Agenda Item # 3

SUB-002845-2024

Tillman’s Square Subdivision, Resubdivision of Lots 2 & 4

- Subdivision approval to create two (2) legal lots of record from one (1) existing legal lot of record.

SITE PLAN

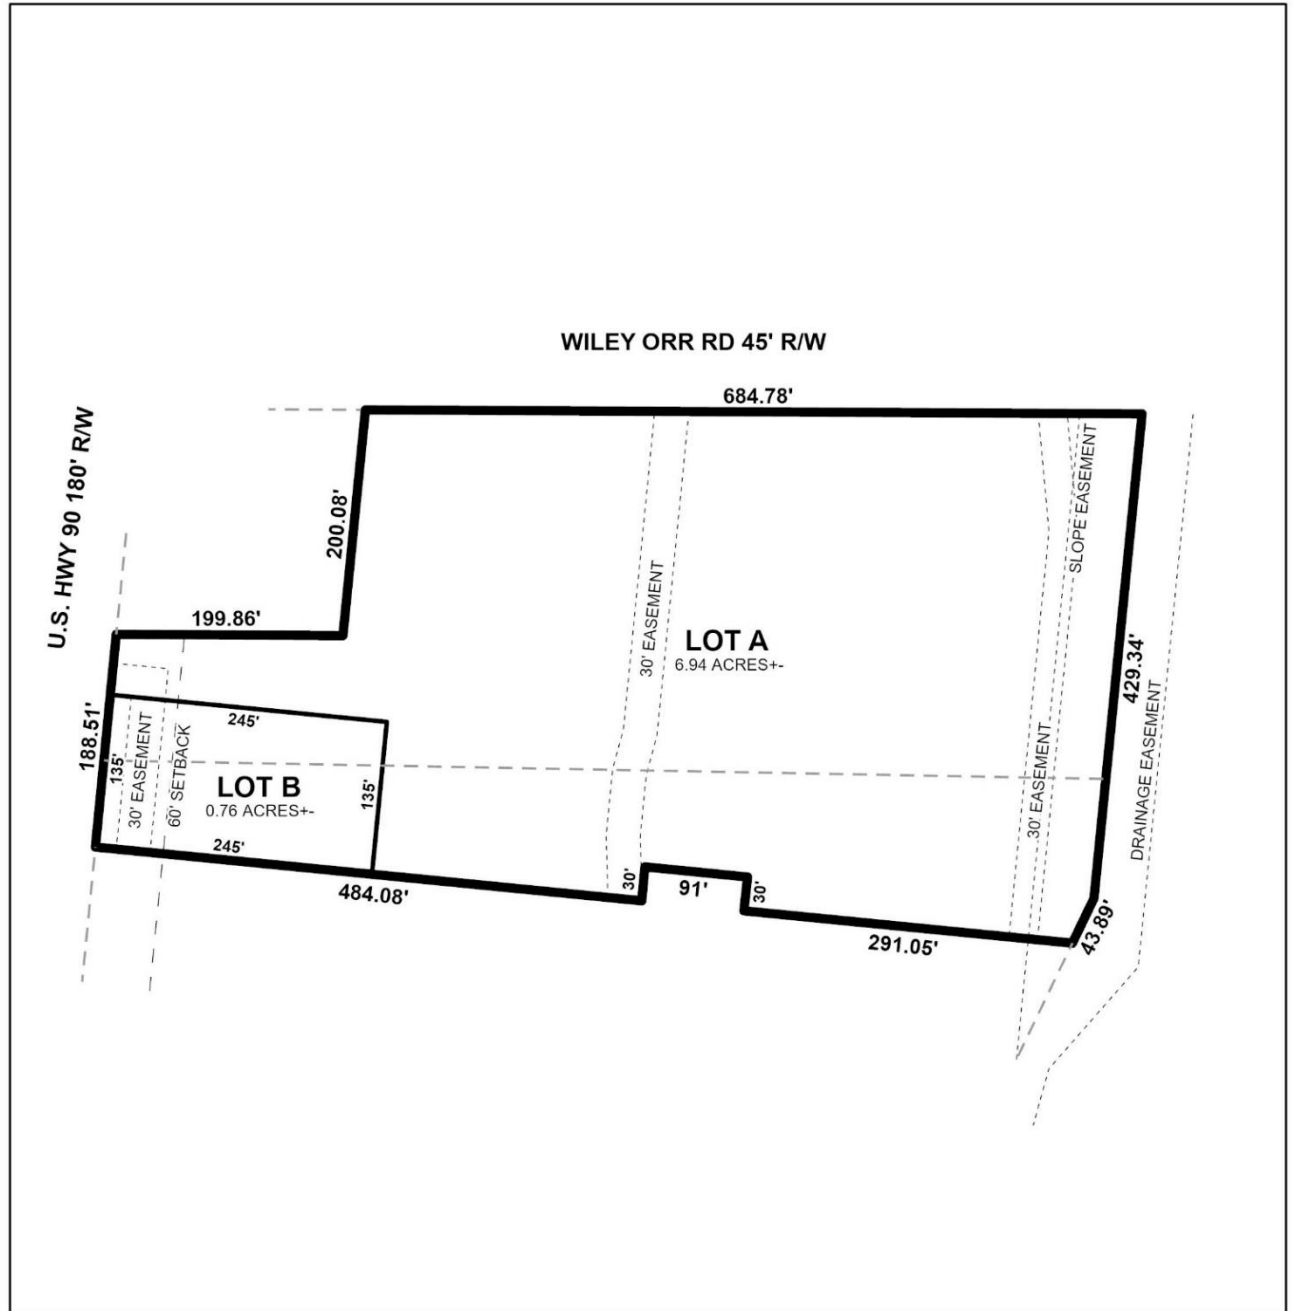
- B. Show and label the correct limits of the existing easements on the east side of LOT A.
- C. Provide the width of the existing SLOPE, SURFACE WATER, DRAINAGE & RETENTION easement shown on the east property line of LOT A.

- D. Show and label the width of the existing SLOPE EASEMENT.
- E. Add a note to the SUBDIVISION PLAT stating that as shown on the 1984 aerial photo (FLIGHT 21 - #90) LOTS A & B will receive historical credit of existing (1984) impervious area towards stormwater detention requirement per Mobile City Code, Chapter 17, Storm Water Management and Flood Control). Applicant will need to coordinate with the City Engineering Permitting Department (G. Davis) to establish the exact amount that each Lot will receive prior to the submittal of the Final Plat from review.

The proposed lots, Lots A and B, have frontage on U.S. Highway 90 West, a Principal Arterial street with a compliant 180-foot right-of-way; as such, no additional dedication should be required. Lot A has additional frontage along Wiley Orr Road, a minor street without curb and gutter requiring a 60-foot right-of-way. The Preliminary Plat illustrates a sub-standard 45-foot right-of-way at this location. As such, if approved, the Final Plat should be revised to illustrate dedication sufficient to provide 30 feet from the centerline of Wiley Orr Road.

A 60-foot front yard setback is illustrated along U.S. Highway 90 West. The proposed setback exceeds the 25-foot minimum required by Section 64-2.14.E. of the UDC for lots in a B-3 Suburban district, but the proposal appears to accommodate a 30-foot non-exclusive easement for ingress/egress. If approved, at least a 30-foot setback should be illustrated on the Final Plat.

The Preliminary Plat does not illustrate a compliant 25-foot front yard setback along Wiley Orr Road. If approved, the Final Plat should be revised to illustrate a front yard setback along Wiley Orr Road, in compliance with Section 64-2.14.E. of the UDC, adjusted for any required dedication.

As proposed, Lot A is an irregular, flag-shaped lot. Such a lot design is discouraged by Section 6.C.9. of the Subdivision Regulations unless varied and irregularly shaped lot designs are common in the vicinity. However, the lot also fronts Wiley Orr Road and there are existing flag-shaped lots in the vicinity of the site, some of which were approved by the Planning Commission under various subdivision requests; therefore, a waiver of Section 6.C.9. may be appropriate.

The Preliminary Plat illustrates multiple easements across both proposed lots, which should be retained on the Final Plat, if approved. Additionally, if approved, a note should be included on the Final Plat stating that no structure may be constructed or placed within any easement without the permission of the easement holder.

1. Retention of the right-of-way along U.S. Highway 90 West as depicted on the preliminary plat;
2. Provision of dedication sufficient to provide 30 feet from the centerline of Wiley Orr Road;

3. Retention of at least a 30-foot front yard setback along U.S. Highway 90 West on the Final Plat;
4. Revision of the plat to illustrate a 25-foot front yard setback along Wiley Orr Road, adjusted for any required dedication;

6. Placement of a note on the Final Plat stating that no structure may be constructed or placed within any easement without the permission of the easement holder;
